KARIMBLA Constructions Services (NSW) Pty Ltd

Section 96(1A) Application – Amend condition 16 of DA2015/0612 to allow for removal of tree 16

This letter comprises a formal request to Warringah Council under Section 96(1A) of the *Environmental Planning and Assessment Act 1979* to modify DA2015/0612 to allow for the removal tree 16.

Figure 1: Approved construction access points during excavation phase (extract from Construction Traffic Management Plan v.6 prepared by SBMG)

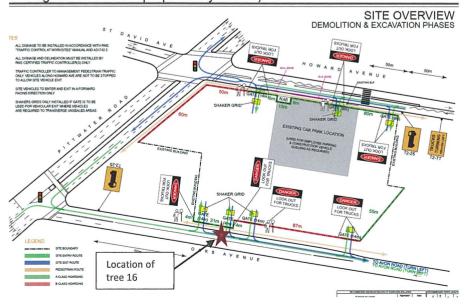
As specified in the Aborist Report which accompanied the DA the removal of Tree 16 is required to allow access to the site. The figure below shows the access points approved by Council for the excavation process.

Tree 16 directly obstructs access into the site. Its removal is essential to the safe operation of the site during the excavation process.

As the removal of the tree is an essential component of the construction methodology for the proposed excavation of the site we seek to amend Condition 16 to allow for the removal of Tree 16 as follows (deleted text shown in strikethrough):

"16. Tree protection and roots

(a) Existing trees which must be retained (Tree Root Protection)
Trees numbered 1, 2, 3, 4, 5, 6, 7, 8, 9, 10, 11, 12, 13, 14, 16, 15, 17, 18, 19, 20 and 21 in the Aboricultural Assessment Report dated 21 January 2015 prepared by TALC"
